**DOCUMENT 00 94 10
CHANGE ORDER****Change Order No. 7**

Project: Promontory Lift Station

Description: Pump manufacturer changed inlet/outlet from designed sizes. Change accounts for additional reducer fitting.

Subject: Lift Station Pump Sizing

Drawing Reference: A101, A301

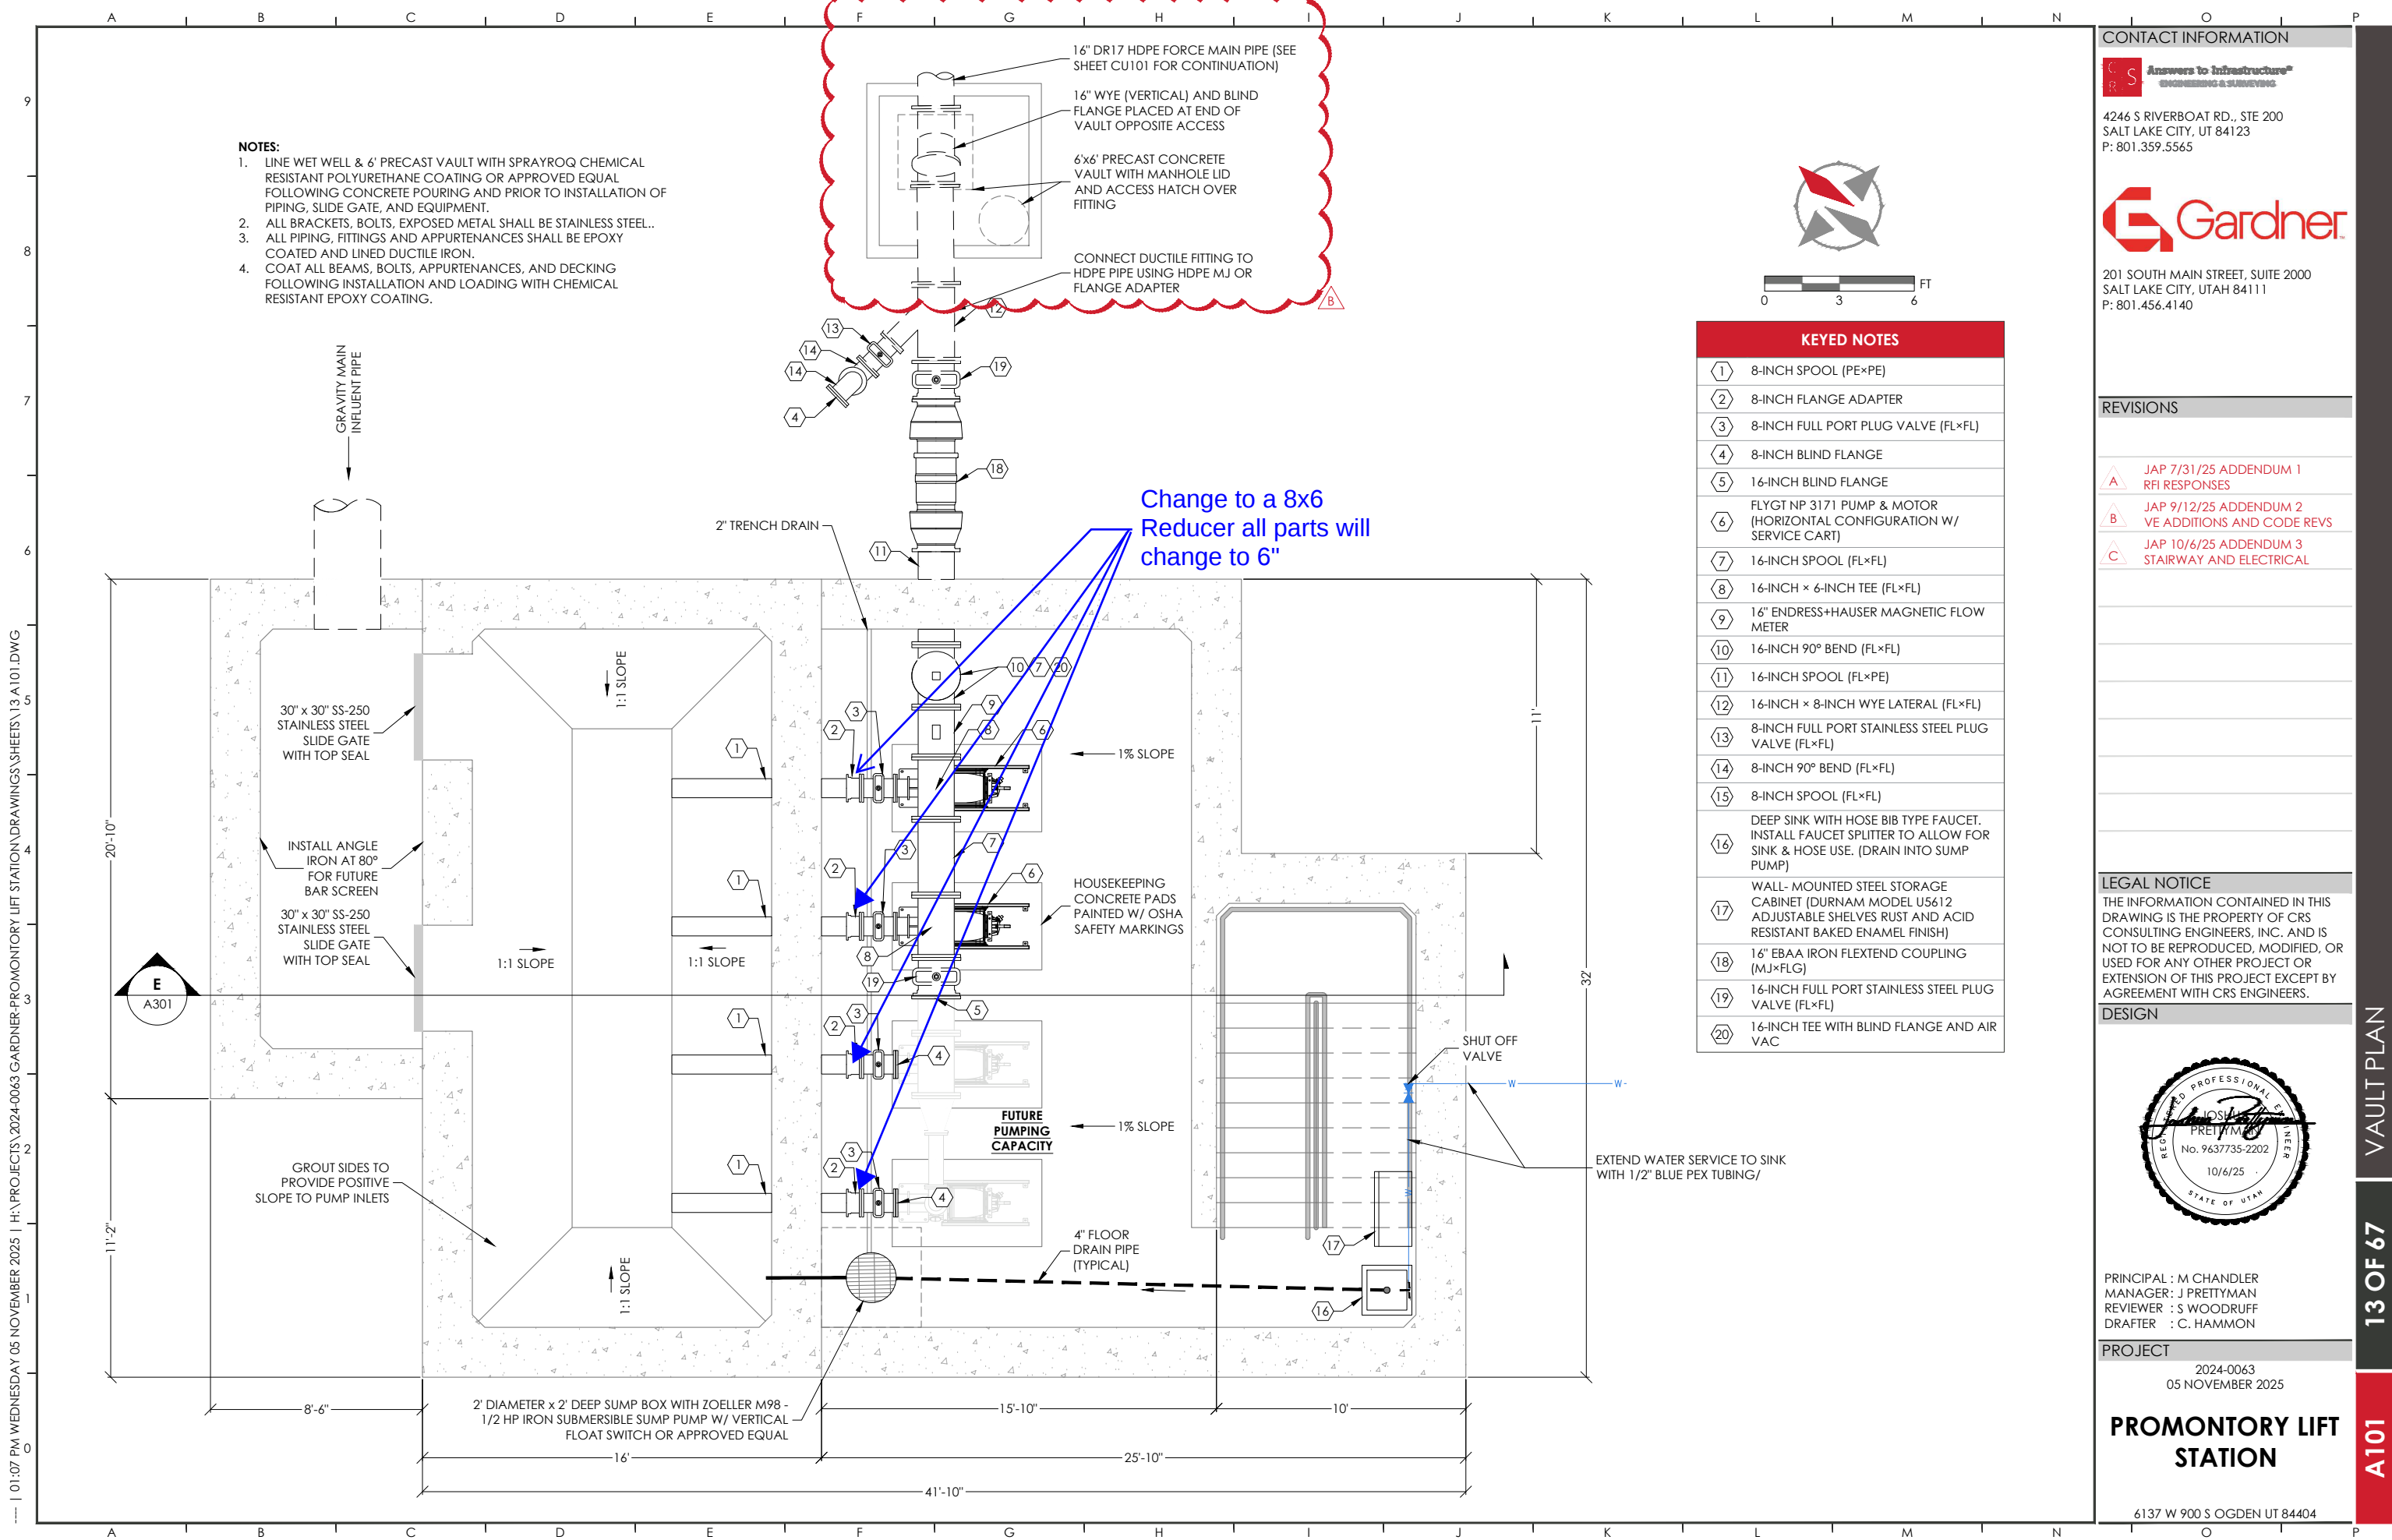
BHI requests confirmation regarding the proposed reducer sizes indicated for the referenced areas of the attached plan sheets.

For the areas identified on Sheet A101, BHI requests confirmation that use of an 8" x 6" reducer is acceptable for installation.

For the areas identified on Sheet A301, BHI requests confirmation that use of a 6" x 4" reducer is acceptable for installation.

Please review and confirm whether these reducer sizes are acceptable as proposed, or advise if an alternate size or configuration is required to meet design intent and project requirements.

Reduction to 6" is acceptable as long as the line through the wet well remains larger. Schematic appears to align with that.
